### Hailey Planning and Zoning Commission

Tuesday, September 3, 2024

- [PH 1](#) Consideration of a of a Preliminary Plat Subdivision Application for Sunbeam Subdivision (Phase II), submitted by Marathon Partners, LLC, and represented by Opal Engineering and BYLA, wherein Sunbeam Subdivision Phase I, Parcels B and C, are subdivided into 62 lots (42 lots and 20 sublots), as well as Parcel B1, which includes the remaining park dedication of 3.34 acres as contemplated in the approved Planned Unit Development Agreement. **ACTION ITEM**
- [PH 2](#) Consideration of a Design Review Application, submitted by Advocates for Survivors of Domestic Violence & Sexual Assault, represented by Bliss Architecture, for the construction of a new 23,347 square foot mixed-use building consisting of office space

Rockridge Townhomes Exterior materials and colors

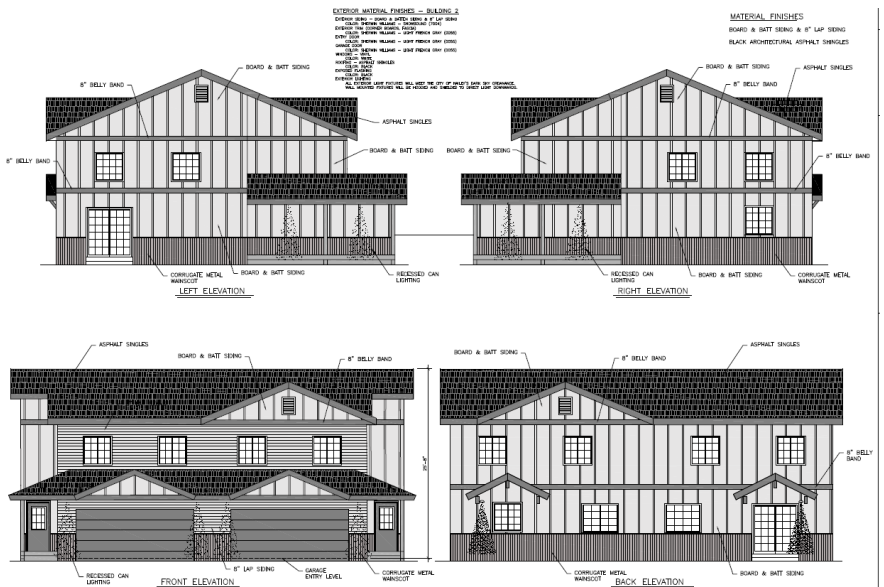
*The Commission suggested the Applicant shift the proposed townhome colors so there are not two (2) of the same panel colors next to one another. The Commission suggested that the building colors to change: 3 and 7 (Kingsport Grey) and 2 and 8 (Snowbound)*
